SERIAL: HNP-00-092

SHEARON HARRIS NUCLEAR POWER PLANT
DOCKET NO. 50-400/LICENSE NO. NPF-63
REQUEST FOR LICENSE AMENDMENT
SUPPLEMENTAL INFORMATION - PRESSURE TEMPERATURE REQUIREMENTS

SHEARON HARRIS NUCLEAR POWER PLANT
NRC DOCKET NO. 50-400/LICENSE NO. NPF-63
REQUEST FOR LICENSE AMENDMENT
SUPPLEMENTAL INFORMATION - PRESSURE TEMPERATURE REQUIREMENTS

TECHNICAL SPECIFICATION PAGES

FIGURE 3.4-2
 REACTOR COOLANT SYSTEM
 COOLDOWN LIMITATIONS - APPLICABLE UP TO 36 EFPY

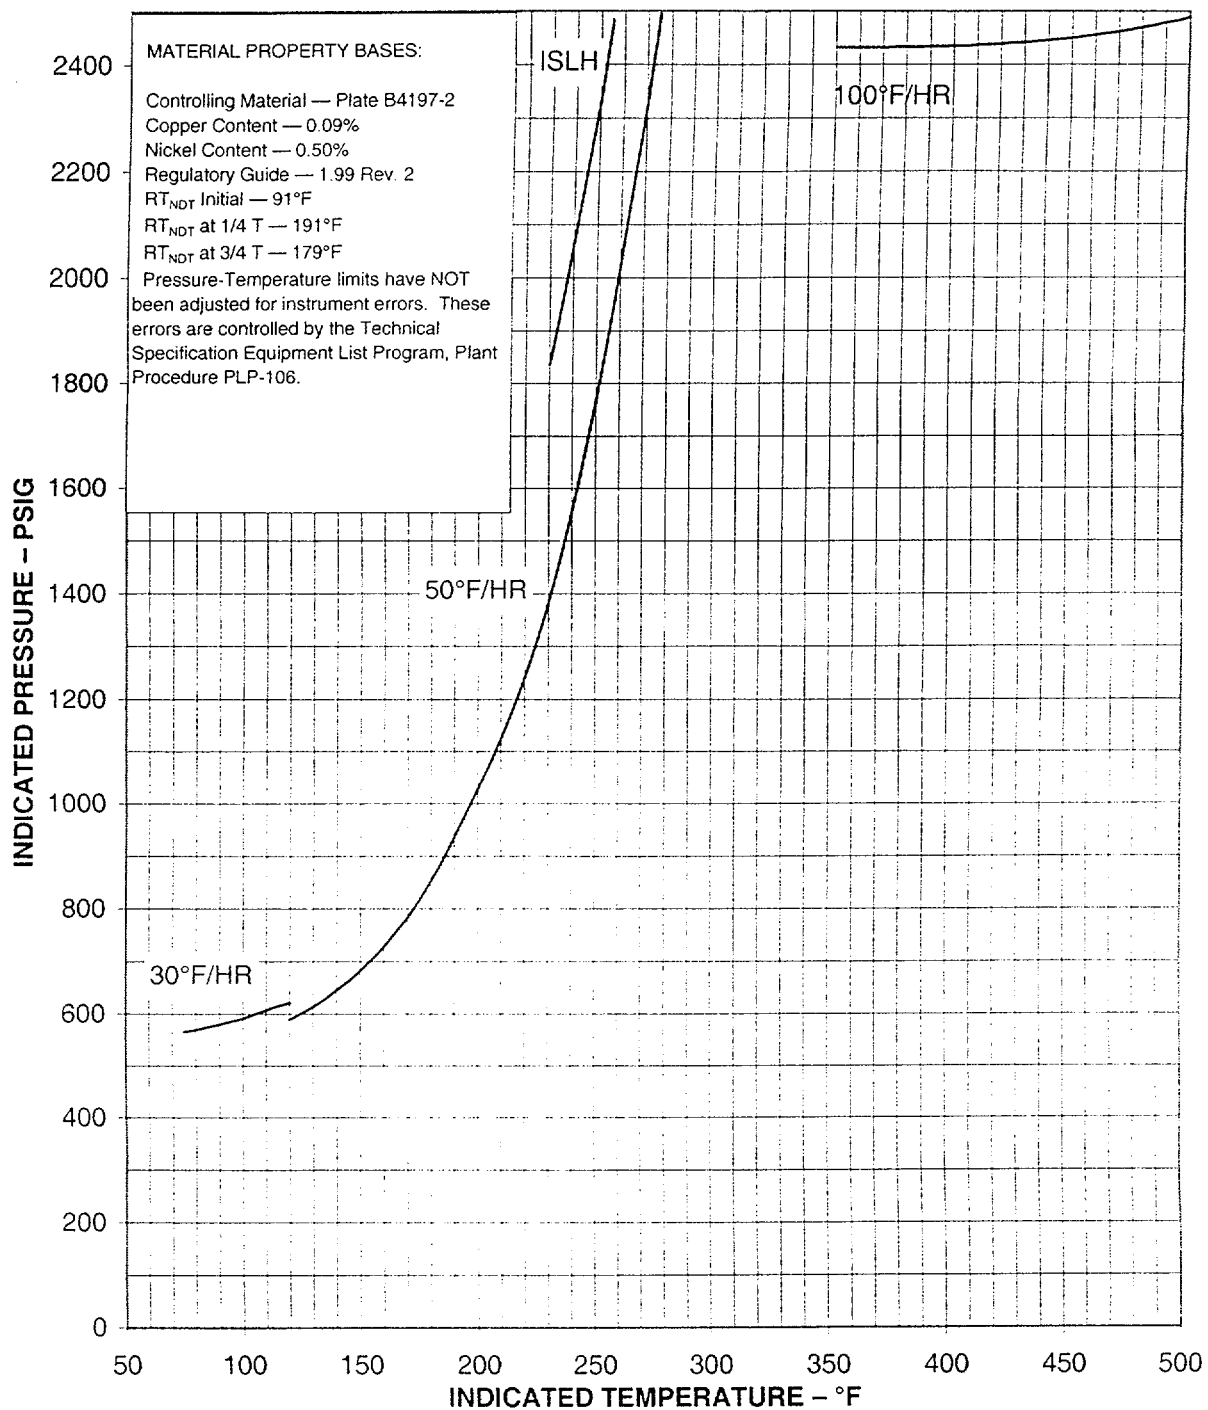
After further discussions with the staff, HNP is hereby withdrawing the request for an exemption to 10 CFR 50.60 (a) based on WCAP-15315. HNP continues to request an exemption to 10 CFR 50.60 (a), based on ASME Code Case N-640.

Enclosure 1 contains the retyped TS pages which incorporate changes resulting from withdrawal of the exemption request based on WCAP-15315.

ASME Code Case N-640,

The temperature and pressure changes during heatup and cooldown are limited to be consistent with the requirements given in the ASME Boiler and Pressure Vessel Code, Section XI, Appendix G, and 10 CFR 50 Appendix G and H. 10 CFR 50, Appendix G also addresses the metal temperature of the closure head flange and vessel flange regions. The minimum metal temperature of the closure flange region should be at least 120°F higher than the limiting RT NDT for these regions when the pressure exceeds 20% (621 psig for Westinghouse plants) of the preservice hydrostatic test pressure. For Shearon Harris Unit 1, the minimum temperature of the closure flange and vessel flange regions is 120°F because the limiting RT NDT is 0°F (see Table B 3/4 4-1). The Shearon Harris Unit 1 cooldown and heatup limitations shown in Figures 3.4-2 and 3.4-3 and Table 4.4-6 are not impacted by the 120°F limit.

The temperature and pressure changes during heatup and cooldown are limited to be consistent with the requirements given in the ASME Boiler and Pressure Vessel Code, Section XI, Appendix G, ASME Code Case N-640, and 10 CFR 50 Appendix G and H. 10 CFR 50, Appendix G also addresses the metal temperature of the closure head flange and vessel flange regions. The minimum metal temperature of the closure flange region should be at least 120°F higher than the limiting RT NDT for these regions when the pressure exceeds 20% (621 psig for Westinghouse plants) of the preservice hydrostatic test pressure. For Shearon Harris Unit 1, the minimum temperature of the closure flange and vessel flange regions is 120°F because the limiting RT NDT is 0°F (see Table B 3/4 4-1).

1. The reactor coolant temperature and pressure and system cooldown and heatup rates (with the exception of the pressurizer) shall be limited in accordance with Figures 3.4-2 and 3.4-3 and Table 4.4-6 for the service period specified thereon:
 - a. Allowable combinations of pressure and temperature for specific temperature change rates are below and to the right of the limit lines shown. Limit lines for cooldown rates between those presented may be obtained by interpolation; and
